## LiDAR Quality Assessment Report

**MO\_Atchison-Holt-Andrew\_2013**

2016-02-16

Checkpoint Distribution Image

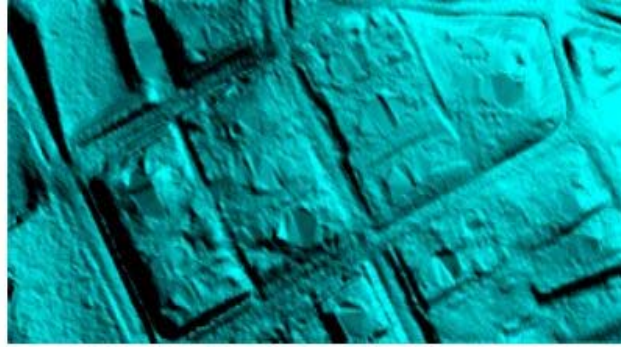
Point 2\_27U was removed from Urban class. Point did not lie within the DEM area. See image.

2\_27U

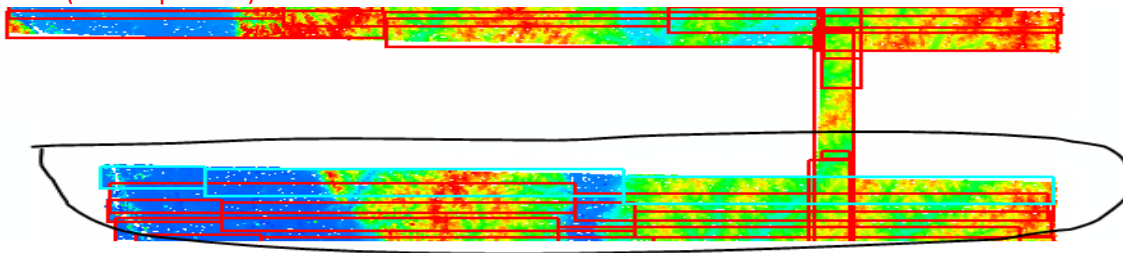
**\*2/19/2015\*** Corrections which arrived in house 2-18-15 did not contain adequate amount of data to fill void in swath. (circled portion)

Complete re-delivery of all swath files is requested.

2-10-2016

Vendor corrected.

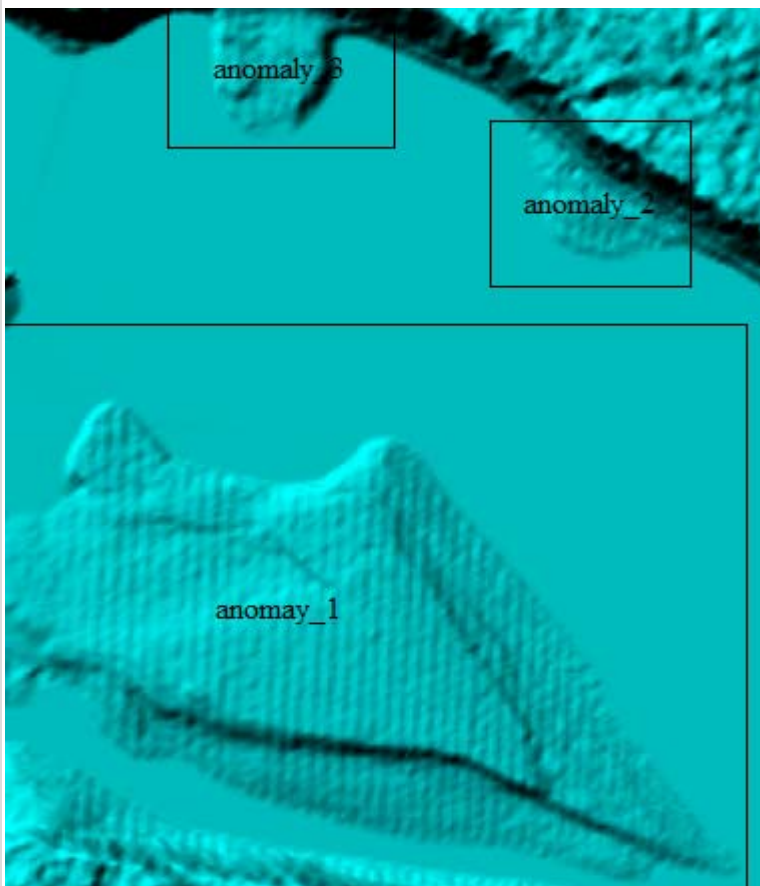
Possible sensor error may explain pattern change anomaly. Please correct.

\*2/18/2015 vendor corrected\*
